**NO:** PC-426  
**DATE:** October 2021

**PRODUCT:** W4S1-03B L2  
**TYPE:** Discontinuation Notice

## Discontinuation and Replacement of the W4S1-03B L2 Switch

**[ Wire connection ]**

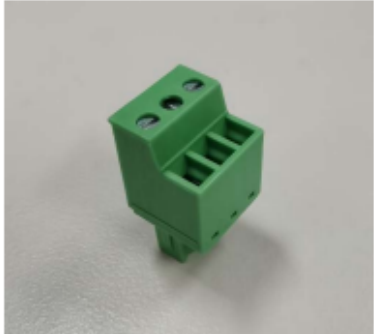
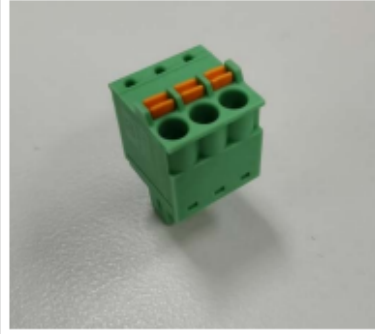
- The power connection method will be changed from the screw type to the push-in type.
- The product will not conformed for NK,LR nor DNV standard.
- The W4S1-03B has 3 ports and the replacement W4S1-05D has 5

<b>Product discontinuation Model W4S1-03B</b>	<b>Recommendable replacement Model W4S1-05D</b>
<p><b>Screw type</b></p>  	<p><b>Push-in type</b></p>

**[ Dimensions ]**

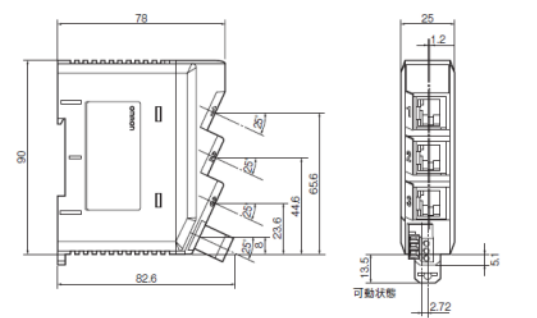
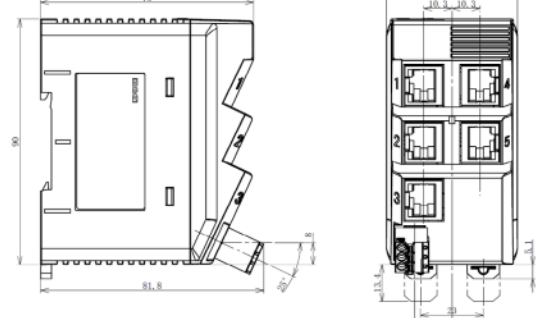
<b>Product discontinuation Model W4S1-03B</b>	<b>Recommendable replacement Model W4S1-05D</b>
